**UNITED STATES ENVIRONMENTAL PROTECTION AGENCY  
REGION III  
1650 Arch Street  
Philadelphia, Pennsylvania 19103-2029**

Re: Public Notice No. 2007-182-1-GAU; Alex Energy, Inc; Federal Surface Mine;  
Nicholas County, West Virginia

**Enclosure**  
**Detailed Technical Comments- Federal Surface Mine, Nicholas County, WV**

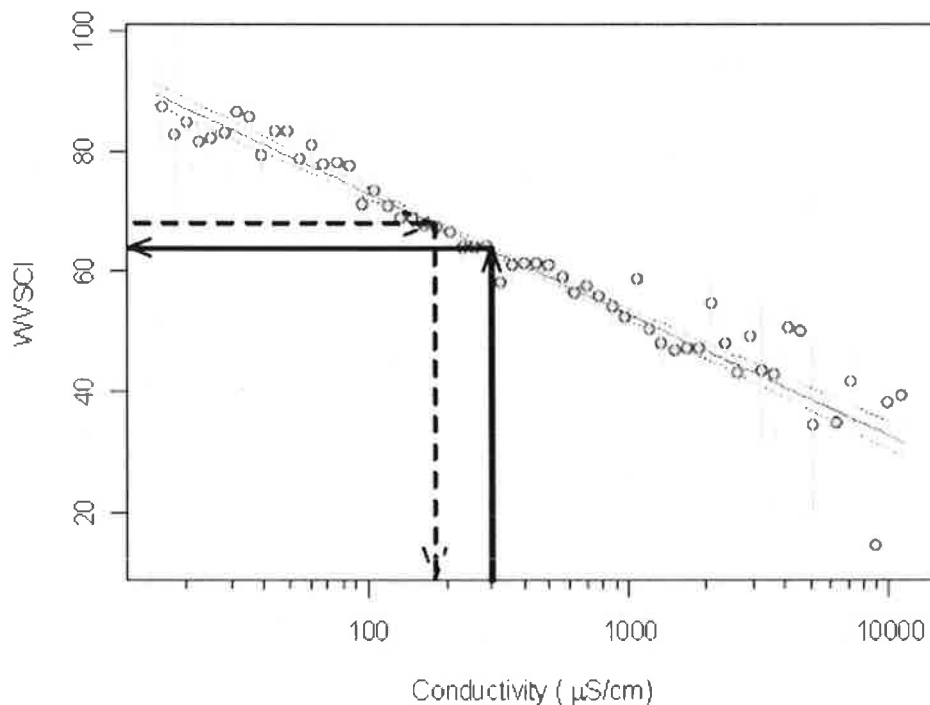
For these reasons, EPA believes that the conductivity trigger level proposed by the applicant (1121.6  $\mu\text{S}/\text{cm}$ ) is not appropriate. A summary of some, but not all, of the peer-reviewed studies considered by EPA is provided below:

Based upon the recently published Office of Research and Development's report, *A Field-Based Aquatic Life Benchmark for Conductivity in Central Appalachian Streams (Benchmark Conductivity Study)*, we estimate that 35% of native macroinvertebrates (61 genera) expected at regional reference conditions would be extirpated at the conductivity level proposed by the applicant (1121.6  $\mu\text{S}/\text{cm}$ ). The graphics of WVSCI vs. conductivity provided by the applicant are incomplete because they do not show the full range of conductivity. The lowest conductivity level shown is 500  $\mu\text{S}/\text{cm}$  and the highest conductivity level shown is 1500  $\mu\text{S}/\text{cm}$ . We offer the following example of a peer reviewed and scientifically defensible analysis of the association between mean WVSCI and binned conductivity levels (taken from the ORD conductivity benchmark report which was subjected to external peer review through the US EPA Science Advisory Board (SAB)). This analysis shows a strong and significant relationship between decreasing WVSCI scores and increasing conductivity.

While the applicant offers several graphics of WVDEP WAB data to support their position that high conductivity levels are not strongly associated with degraded biological conditions, the data provided by the applicant are not analyzed in a way to correctly explore relationships between elevated conductivity and biological condition. The applicant's analysis fails to filter out other common stressors, such as poor physical habitat or acidic conditions. US EPA ORD analyzed the WVDEP data set using  $\text{WVSCI} \geq 68$  as an endpoint, after filtering out physical habitat degradation and acidic pH. For sites in ecoregion 69d, with good habitat ( $\text{RBP} > 140$ ),  $\text{pH} > 6$ , and conductivity  $> 500 \mu\text{S/cm}$ , 71.3% of the sites (92 of 129) had a WVSCI score less than 68. Conversely, those sites with good habitat ( $\text{RBP} > 140$ ),  $\text{pH} > 6$ , and conductivity  $< 300 \mu\text{S/cm}$ , 82.4% (383 of 465) had WVSCI scores  $\geq 68$ . These data indicate that there is a strong association between elevated conductivity and adverse impact to the expected naturally occurring biological community, after filtering out possible effects from two common stressors, even when the family-level index is used as an endpoint.
